SUBJECT: Part 21 rept 10CFR21-0073 re defect w/voltage adjust potentiometer mfg by Chicago Telephone Supply used on NEI Peebles (Portec) voltage regulators at plant. Util updating voltage regulators w/Maury Instrument Corp potentiometer.

Reference: Report No. 10CFR21-0073

Subject: Reportable defect with NEI voltage regulator
voltage adjust potentiometer

Report No. 10CFR21-0073
FEBRUARY 27, 1996

VOLTAGE ADJUST POTENTIOMETER "R4"
NEI DRAWING A-01068
CHICAGO TELEPHONE COMPANY POTENTIOMETER #115R251A

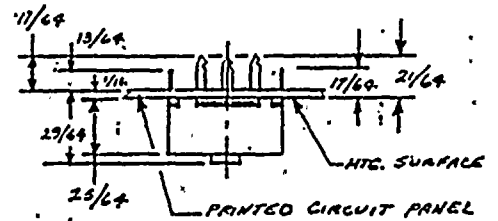
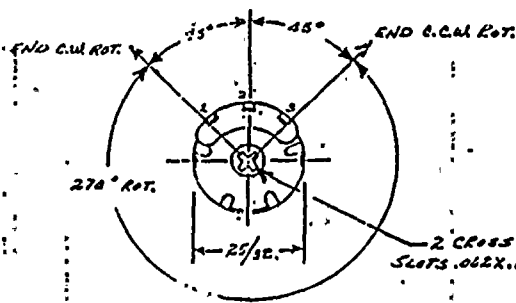
Microscopic examination of the potentiometer showed foreign material on the surface and edge of the stationary slip-ring under the wiper arm collar. The material on the edge was translucent/white-ish and appeared to be a lubricant. The material on the surface was blackish with some white flakes. It is postulated that the lubricate accumulated contaminants and/or dried on the surface. The total amount of foreign material is very small.

- 1) FP&L is in the process of updating their voltage regulators with the Maury potentiometer. Other users should be aware of this possible problem and monitor their EDG output voltage for unstable output during routine testing. Replacement of the potentiometer is dependent upon monitoring/testing. Immediate response to this notification does not appear to be necessary as the majority of the in-service voltage regulators have been operating without incident for approximately 15-20 years.

- 2) The potentiometer is soldered to a circuit board within the voltage regulator assembly; therefore, field modification is not recommended. For replacement of the potentiometer, it is recommended that the regulator be returned to NEI (either directly or through MKW Power Systems) where proper testing can be performed before the regulator is returned to the customer. Contact MKW Parts Department for assistance.

"R4" REPLACEMENT
MAURY #50-M-123-251

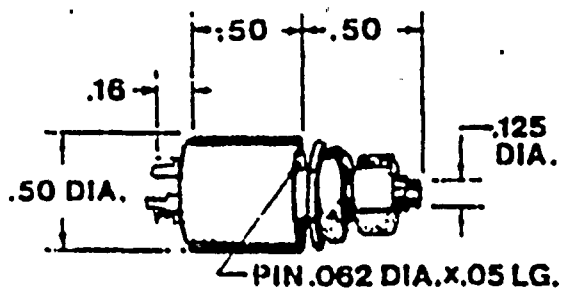
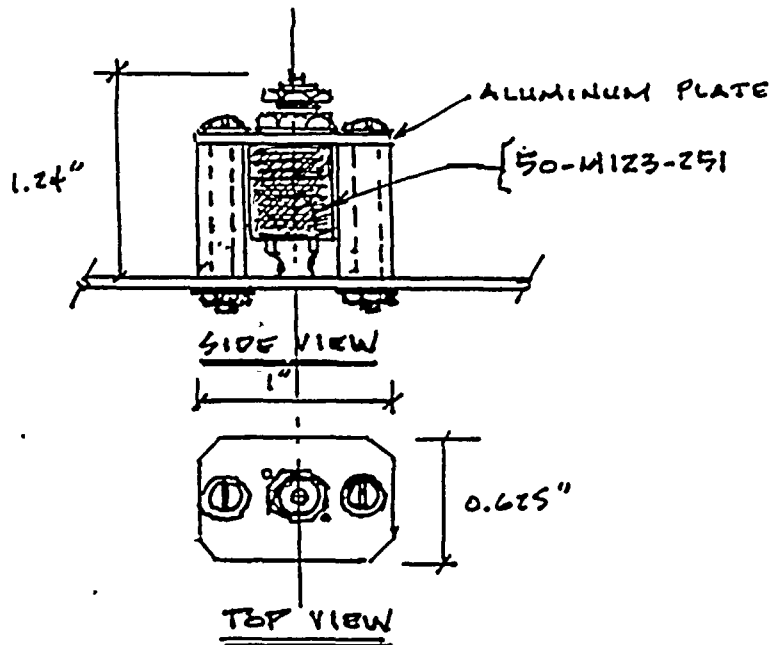
REPLACEMENT FOR 115R251A USED IN VOLTAGE
REGULATOR 72-13000-100 AS RESISTOR R4.
